UNITED STATES PATENT AND TRADEMARK OFFICE

APPLICATION NO.	FILING DATE	FIRST NAMED INVENTOR	ATTORNEY DOCKET NO.	CONFIRMATION NO.
10/828,843	04/21/2004	James A. Perkins	56527.C1/ C-3670.0	5307
408 7590 09/23/2008 LUEDEKA, NEELY & GRAHAM, P.C. P O BOX 1871 KNOXVILLE, TN 37901				
EXAMINER POPOVICS, ROBERT J				
ART UNIT		PAPER NUMBER		
1797				
MAIL DATE		DELIVERY MODE		
09/23/2008		PAPER

Office Action Summary

DETAILED ACTION

Claims 1, 3-12, 14 and 16-33 are rejected under 35 U.S.C. 103(a) as being unpatentable over the combined teachings of **Cheng (US 4,861,352)** and **AAPA (Applicant's Admitted Prior Art)**. **Cheng** discloses an inline stripper:

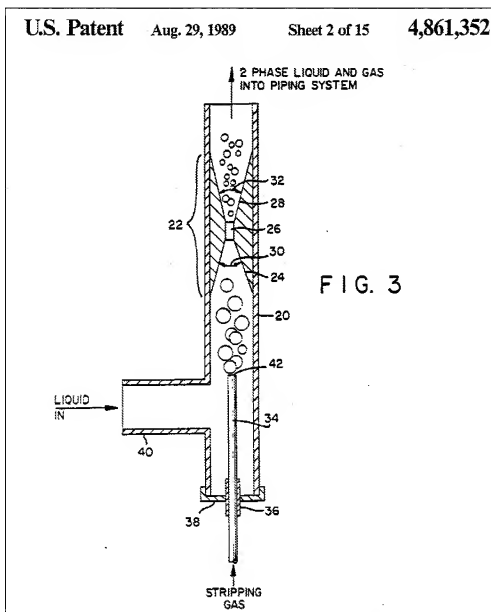
Cheng does not appear to expressly disclose *"establishing a well"* as recited in independent claim 1, or *"at least one well extending from the ground surface to a downhole location,"* as recited in independent claim 12. **AAPA**

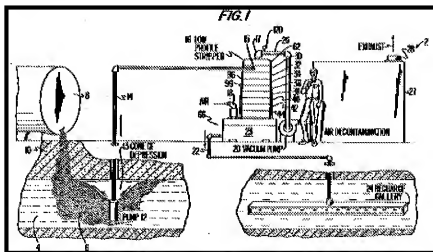
teaches that those structures fore and aft the claimed inline stripper are conventional or well known to those skilled in the art.

AAPA teachings:

Those of ordinary skill are believed to be well-versed in the use of the above and other similar subterranean groundwater/ vapor removal technologies in connection with which the invention may be used.

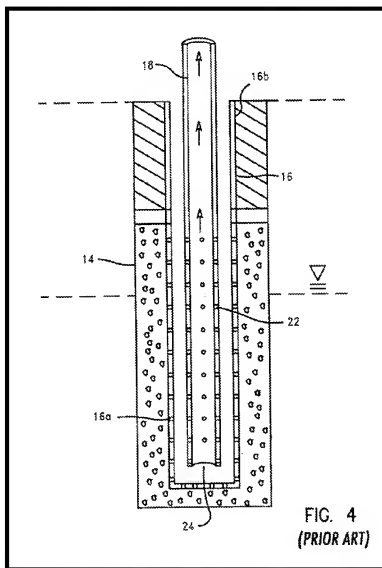
The Cheng reference clearly teaches the use a venturi to strip a gas from a liquid. This is well known in the art. The hypothetical person having ordinary skill in the art is charged with all that is known in the art. Accordingly, the hypothetical person having ordinary skill in the art would have known of such venturi type stripping devices. The substitution of one known stripping device for another is seen to be exceedingly obvious, in the same way that an auto mechanic would know that a car could be jacked up with a floor jack, a scissor jack, a hydraulic bottle jack, or a bumper jack.
